Director's Report

Project Name: Edendale

Description: Final Site Plan Approval

RE: Edendale Crossing- Final Site Plan Review – 1st Review

Site/Grading Plan - Southeast "EDENDALE CROSSING" SITE CONDOMINIUM
PART OF THE SOUTHEAST 1/4 OF SECTION 29, T3N, R9E
WHITE LAKE TOWNSHIP, OAKLAND COUNTY, MICHIGAN

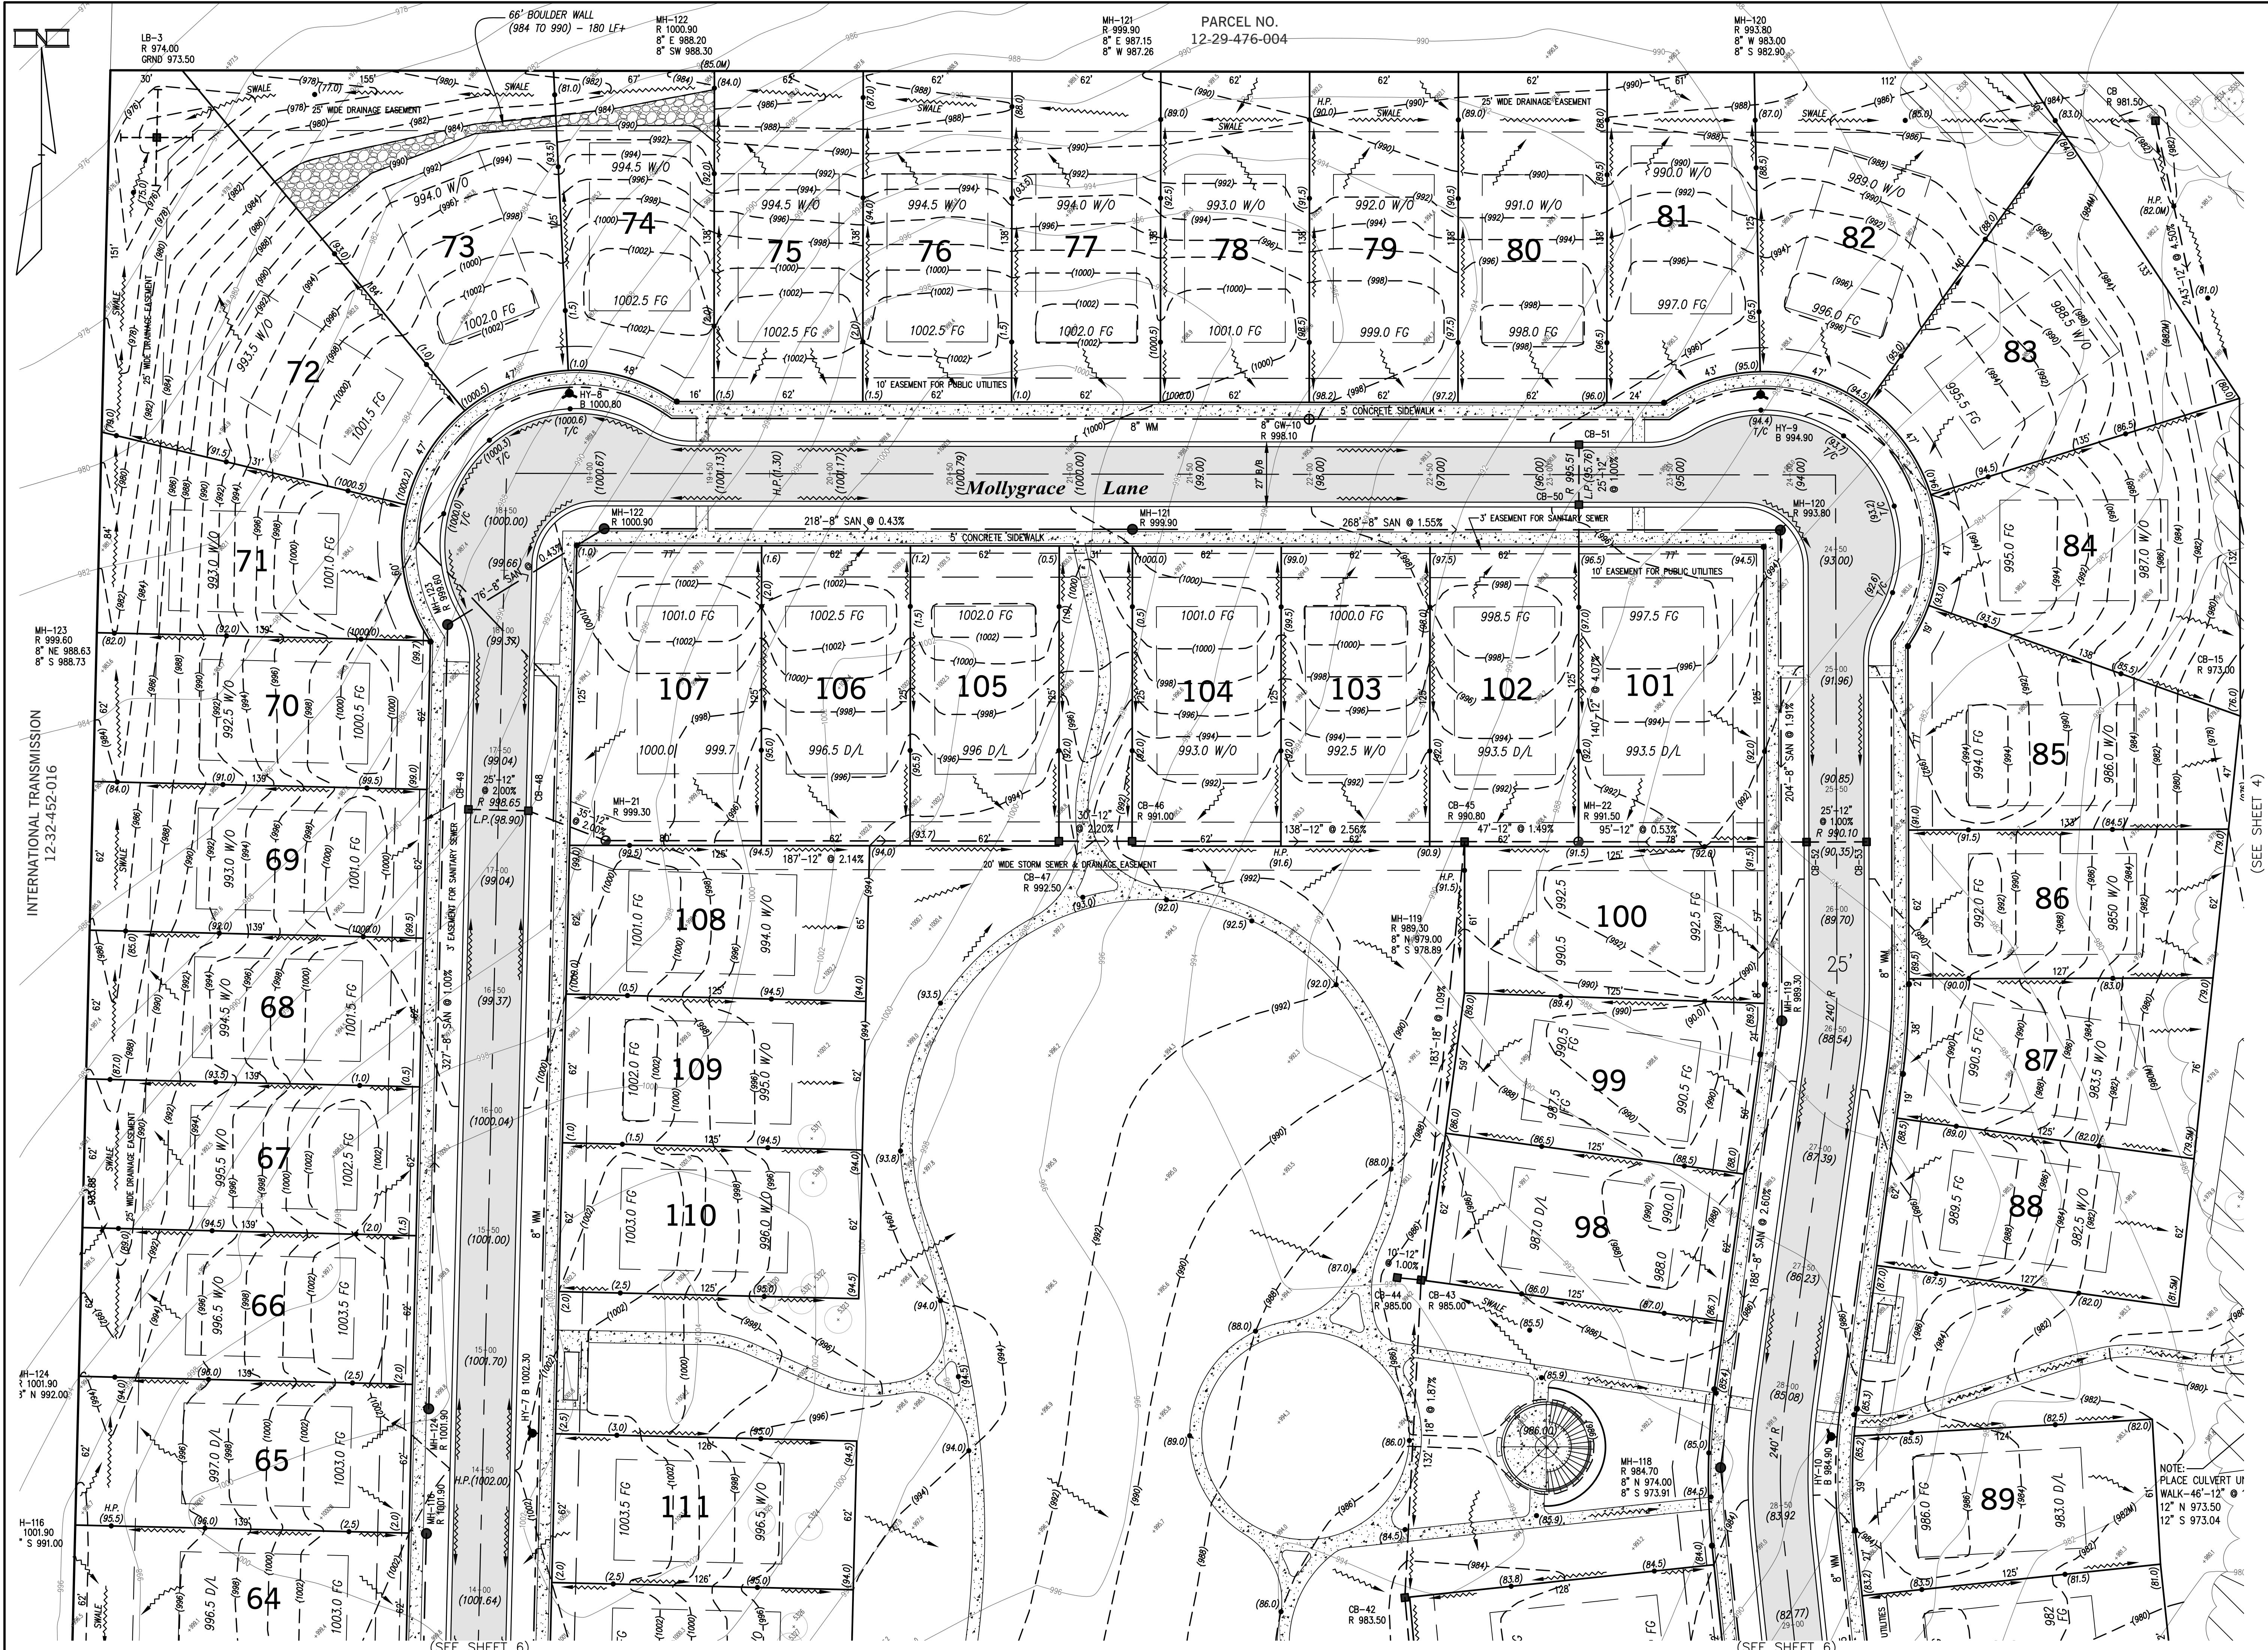
6. *Sheets 5 and 9- Entrance dimensions of Edendale Lane at Cedar Island Road do not correspond to 21' B/B and 16' (island width) when measured per provided scale. Please revise. **Entrance dimensions have been adjusted to 22' B/B widths.***

Bogie Lake Road Entrance Plan
"EDENDALE CROSSING" SITE CONDOMINIUM
PART OF THE SOUTHEAST 1/4 OF SECTION 29, T3N, R8E
WHITE LAKE TOWNSHIP, OAKLAND COUNTY, MICHIGAN

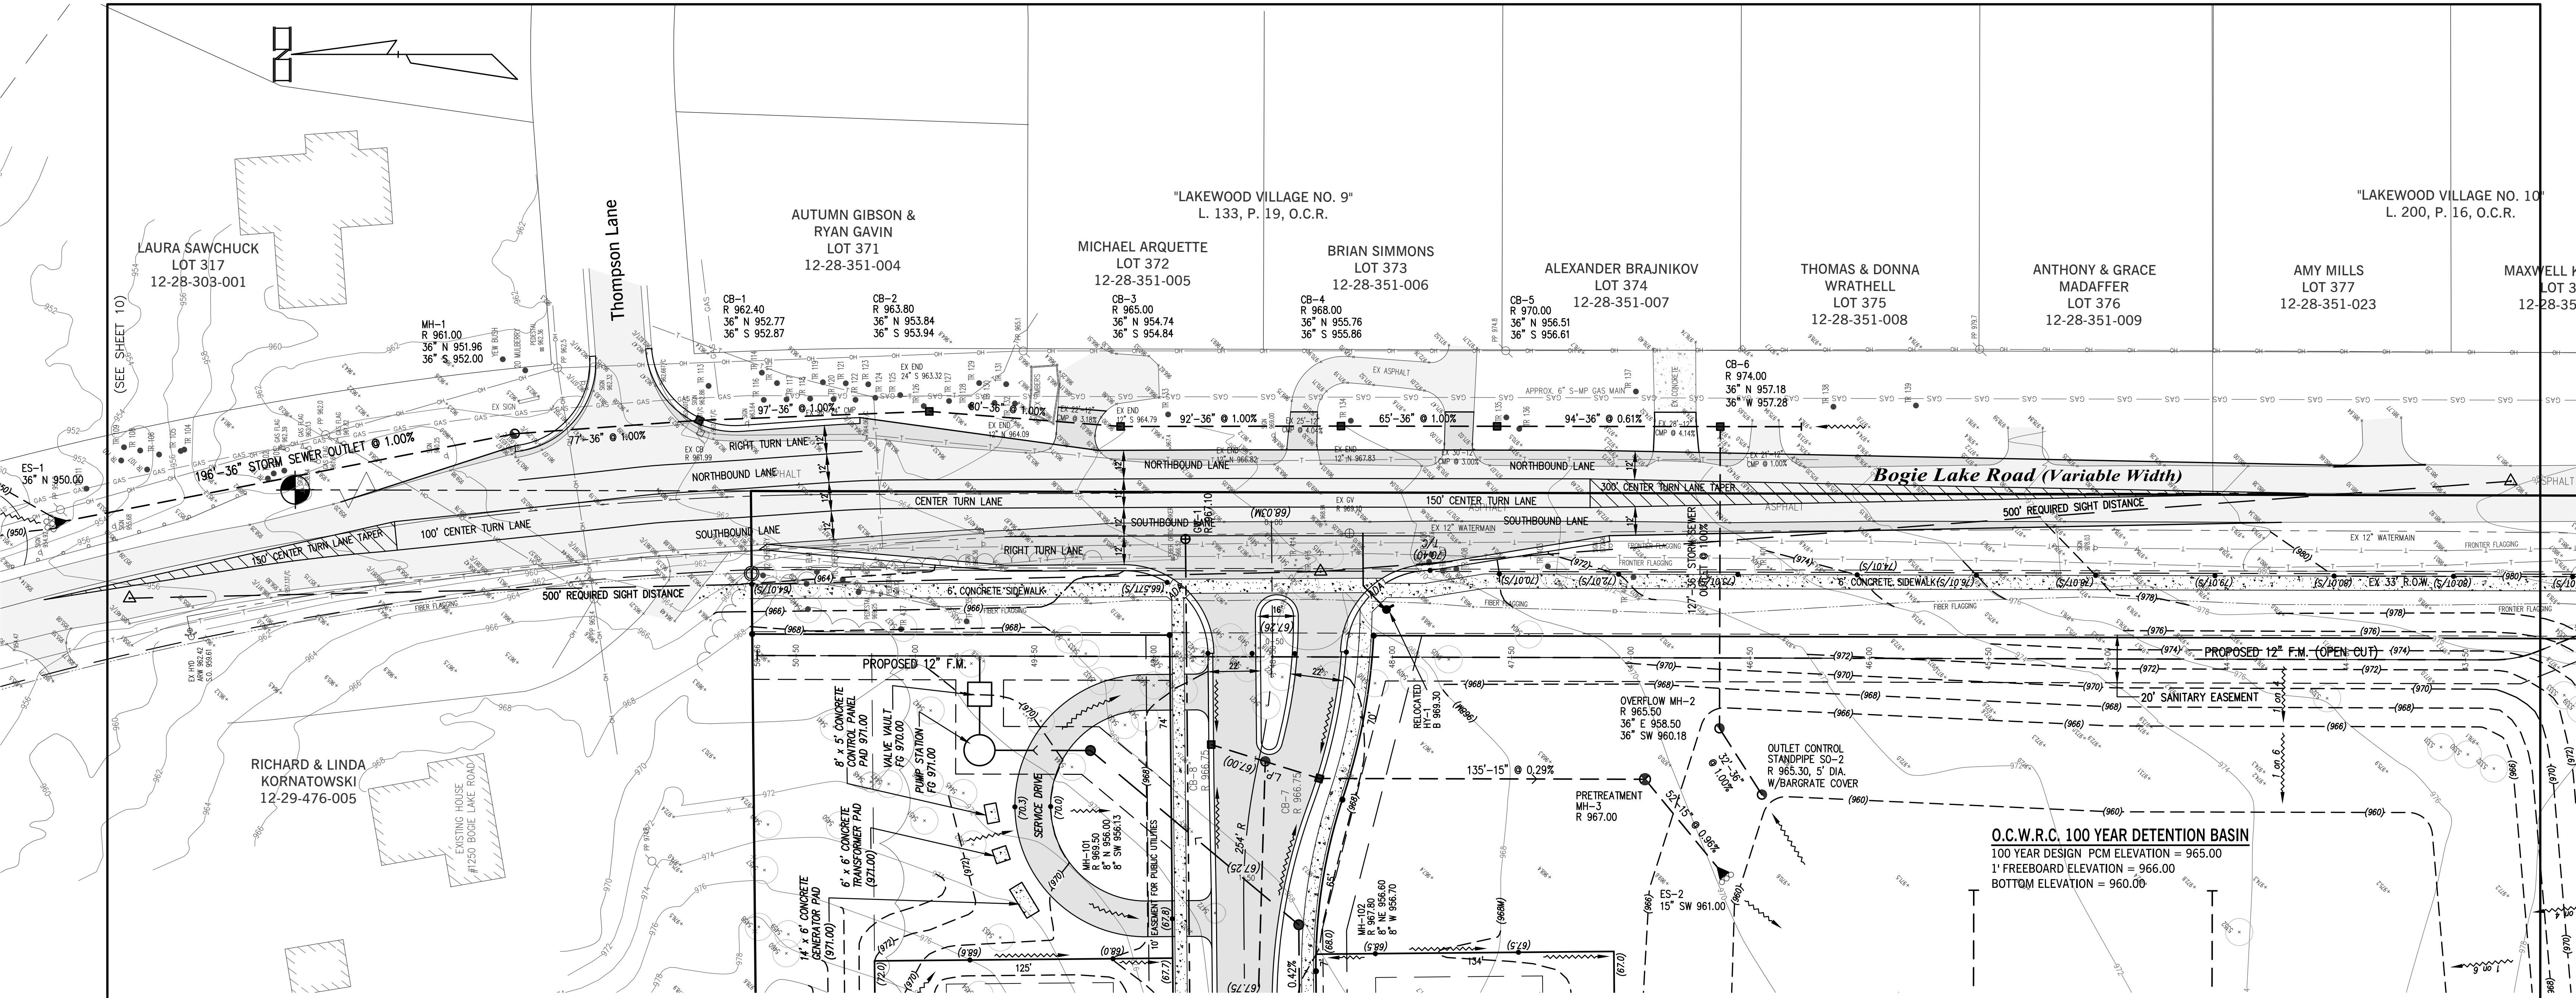
1. Sheet 8- It appears the discharge from the detention pond will flow across Parcel #12-28-303-001 which may require a storm drainage easement unless the storm sewer can be extended to a point there is no conflict. Comment addressed. A ditch that will route where the drainage to Thompson Lake goes is now proposed within the existing road ROW. **Comment remains as a notation.**

2. Sheet 8- The proposed storm sewer layout along Bogie Lake Road will need to be **clarified at the time of ~~Final Site Plan~~/Final Engineering Plan** to work with existing stormwater features, site drainage, and utility poles etc. **Comment remains as a notation.**
